Proposed Modifications to Previously Approved Scheme Reg. Ref SD20A/0283.

Project Title
DUB 14/15
Proposed Modifications to Previously Approved Scheme SDA\0283

Drawing Title
Enlarged Site Plan
Proposed DUB 15
& Admin. Building

Scale at A0	As indicated	By / Chkd / Appd SL/MM/RA
Role	Architecture	
Status	S2 - Suitable for Information - Planning -	
Arup Job No	279225	Rev P02
ID	A1014

1 Enlarged Site Plan - Proposed DUB15
1 : 500

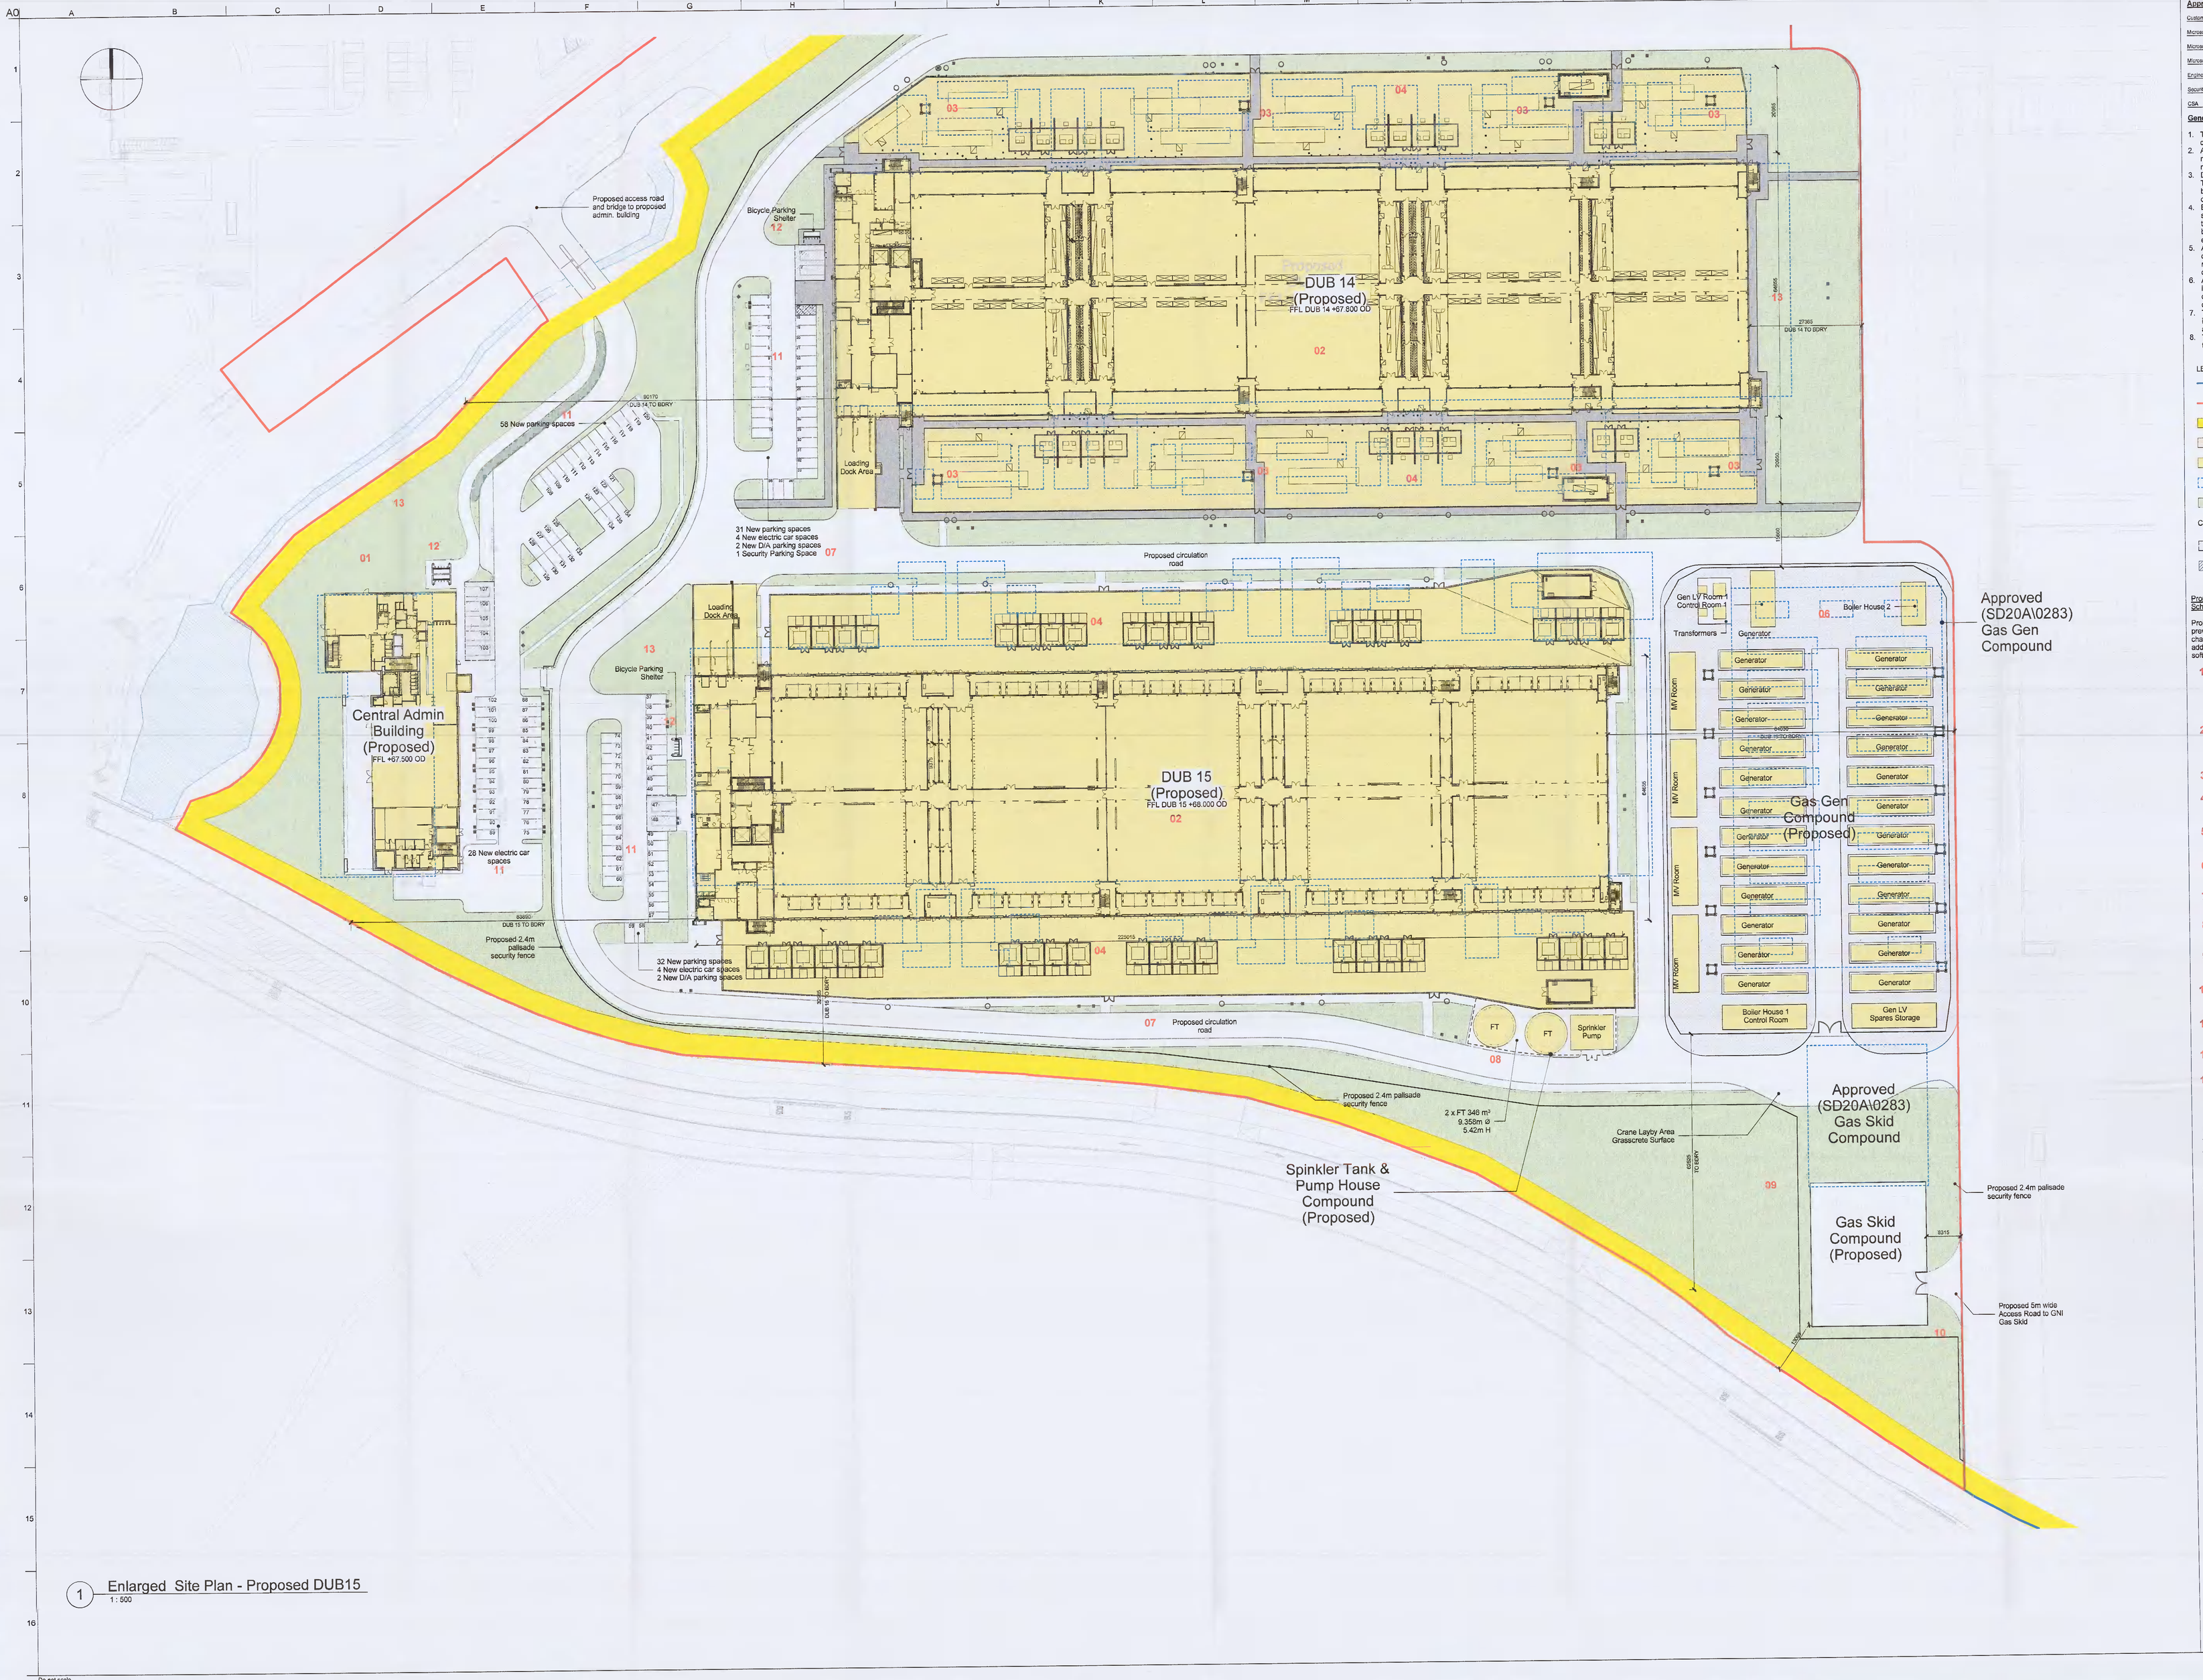
Proposed reconfiguration and revised setting out of previously approved building plans and associated changes to elevations, reconfiguration of and minor additions to miscellaneous plant and changes to hard & soft landscaping layout.

1 1.Approved Central Administration Building (CAB):
a. Building moved to the east by approx. 7m.
b. Increase of building footprint by approx. 170m2 (from 1,424m2 to 1,594m2)
c. Design development - changes to building layouts & elevations (design and finishes).
d. Approved four-storey Office element: Parapet at roof level to be raised by approx. 1.65m.

2 2.Approved Data Centres – DUB14 and DUB15:
a. Reconfiguration of building footprints & reduction in area of approx. 48m2
b. Design development - changes to building layouts & elevations (design and finishes).
c. Omission of zone of sedum roof finish.

3 DUB 14. Reduction in height of approved flues by approx. 650mm.

4 Reconfiguration of associated external plant at ground level (including generators / E-Houses & transformers) flues, modification to design of screening to generator yards, omission of approved Modular Electrical Rooms (MERs) serving approved Data Centres DUB14 &15.

5 Relocation below ground, modifications to design and expansion of approved Water Treatment Building and associated plant.

6 Gas Generator Compound – Relocation & reconfiguration of previously approved gas generator compound including an additional flue.

7 Modifications to approved layout of internal site roads, yards and footpaths.

8 Approved Sprinkler Tanks and Pump House for DUB14 relocated on existing site.
DUB15 Sprinkler Tanks and Pump House relocated south of DUB15

9 Relocation of Approved Gas Networks Ireland (GNI) gas skid & compound including approved 3 no. kiosk buildings.

10 Proposed new vehicular access to serve revised GNI location off the existing Data Centre Compound.

11 Modifications to approved car park layouts and landscaping design

12 Modifications to location and design of approved bicycle shelters

13 Modifications to site development works, including underground water and building services provision, landscaping, internal security and compound enclosure fencing, and associated works
